**U.S. EPR Instrument Setpoint Methodology  
Topical Report**

SUBJECT: FINAL SAFETY EVALUATION REPORT FOR ANP-10275P, "U.S. EPR  
INSTRUMENT SETPOINT METHODOLOGY TOPICAL REPORT"  
(TAC NO. MD4976)

FINAL SAFETY EVALUATION BY THE OFFICE OF NEW REACTORS  
ANP-10275(P), "U.S. EPR INSTRUMENT SETPOINT METHODOLOGY  
TOPICAL REPORT" (TAC NO. MD4976)  
PROJECT NO. 733

### **The Staff's Disposition of AREVA's Comments on the Draft SE**

**Figure 4.2-1 Setpoint Relationships**  
**(for Increasing Process)**

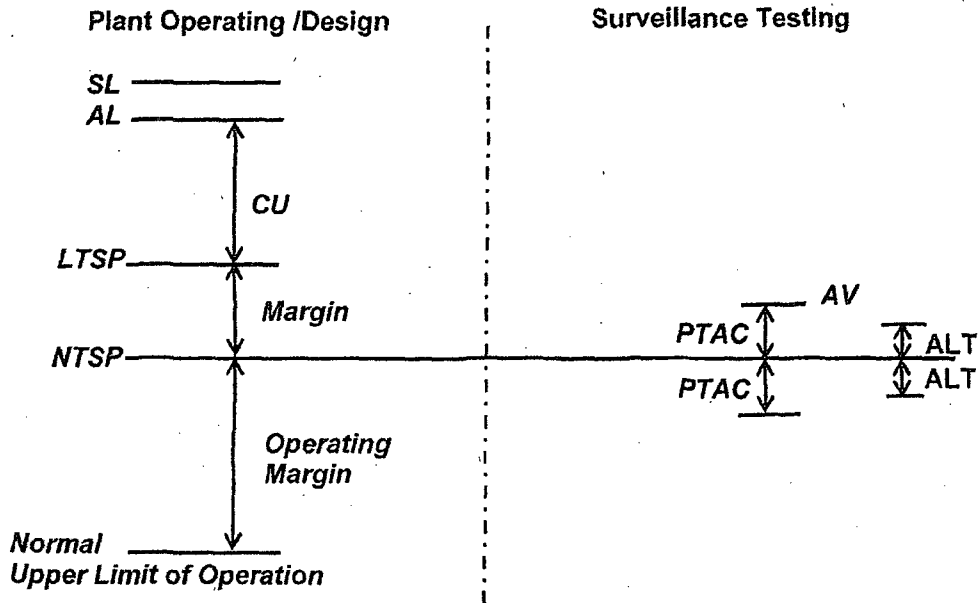
**Response 2:**

The topical report will be revised to reflect that the AV equals the AF tolerance. See attached revised pages to the topical report.

**Attachment: Response to RAI 2 - Revised topical report pages 4-4 and 4-5.**

**Figure 4.2-1 Setpoint Relationships**  
 (for Increasing Process)

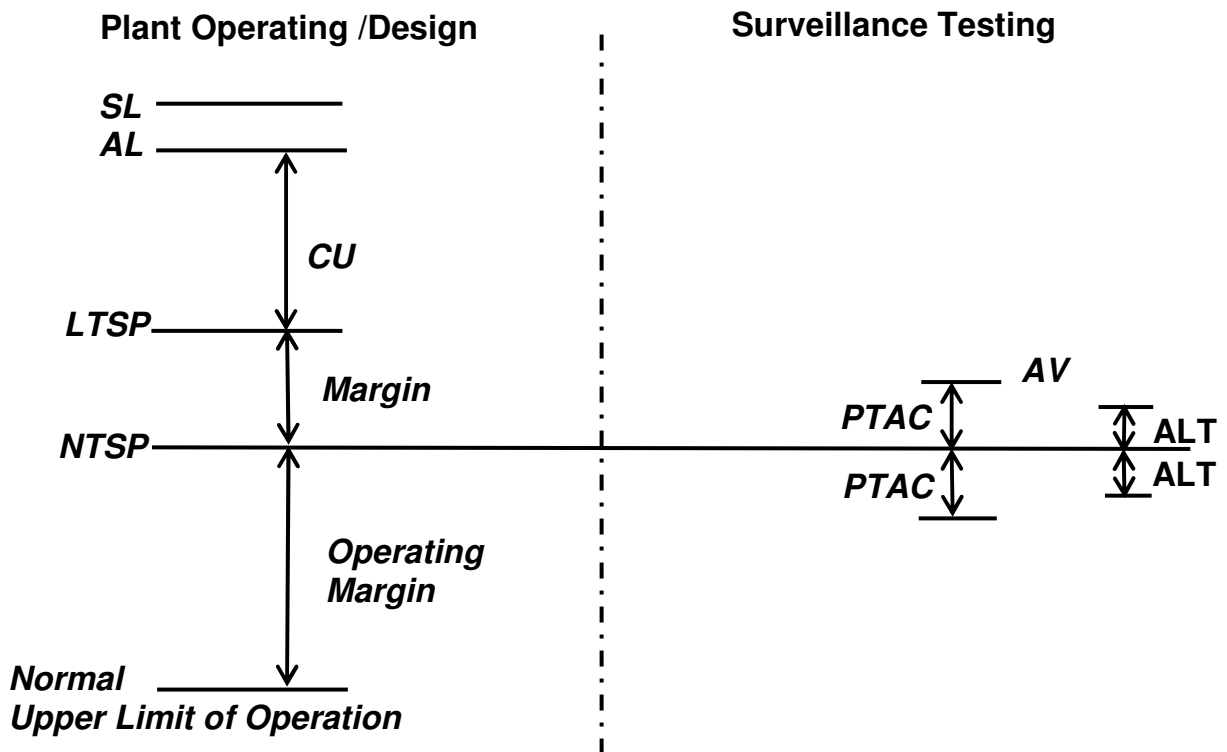
| <b>Section</b> | <b>Page</b> | <b>Change Description</b>   |
|----------------|-------------|---|
|                | 4-5         | Added continuation paragraph of revised AV definition.<br><br>Revised Figure 4.2-1 to reflect revised AV definition.                  |
